Planning & Zoning Commission Meeting Agenda

March 25, 2021 at 6:00 P.M.

Consider action to deny a Site Development Plan for First National Bank on Lot 2 of the Main & Spring Subdivision, located at 714 Spring Street, that was previously denied by the Director of Planning & Development due to non-compliance with the Bastrop Building Block (B³) Code Section 6.3.005 Alleys & Driveway Locations.

SITE DEVELOPMENT PLAN FOR FIRST NATIONAL BANK OF BASTROP

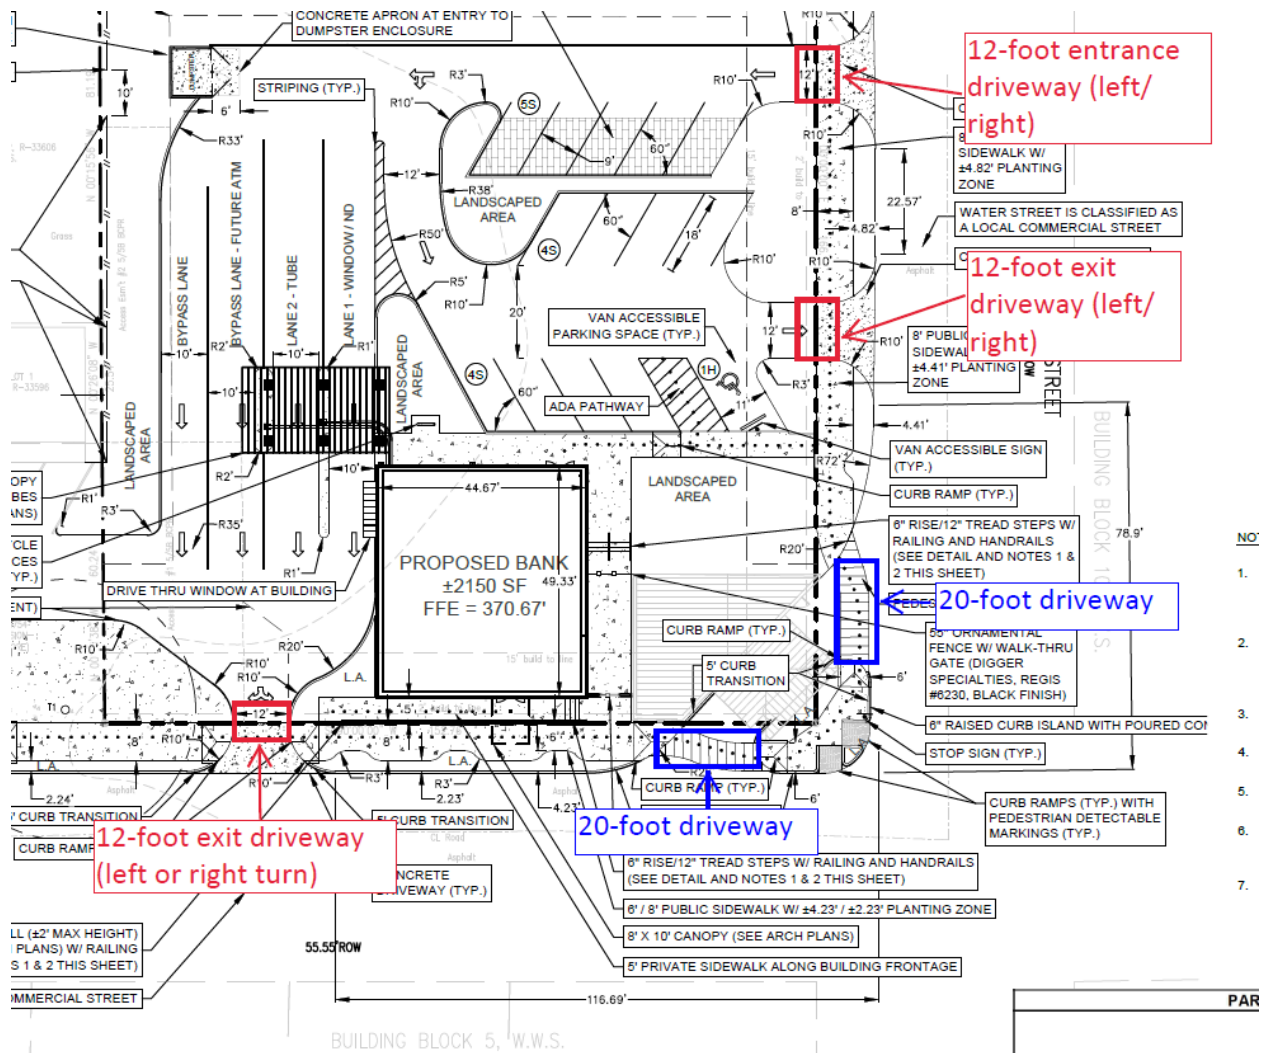
The Development Review Committee members have completed three reviews for compliance with the Bastrop Building Block (B³) Code and have denied approval of the plan for non-compliance with the driveway requirements. Per the Code, on a corner must take access off the Secondary Frontage and sites zoned P-4 or P-5 must have the driveway set a minimum of 40 feet from the street intersection. The B³ Code is designed to create pedestrian focused multi-modal streets. Allowing of multiple auto centric driveways creates multiple breaks in the sidewalk and intersections with the street driving lanes, generating conflicts for pedestrians and other auto traffic.

The site has two existing 20-foot driveways that are approximately 25 feet from the edge of the rights-of-way from Spring and Water Streets (noted in blue). The applicant is proposing to add three new 12-foot driveways, two on Water Street, and one on Spring Street (noted in red).

Per the code requirements, the site is allowed one driveway up to 24-feet wide for two-way traffic on Water Street (secondary frontage). For one way traffic (entrance on Water, exit on Spring) staff was open to considering splitting the 24 feet into two 12-foot drives. Staff also requested making the Cash Station pedestrian only, in order to decrease the total number of drives.

The applicant submitted a Site Development Plan with a total of five driveways, all of which allow full turning movements (full left and right) when entering or exiting the drives.
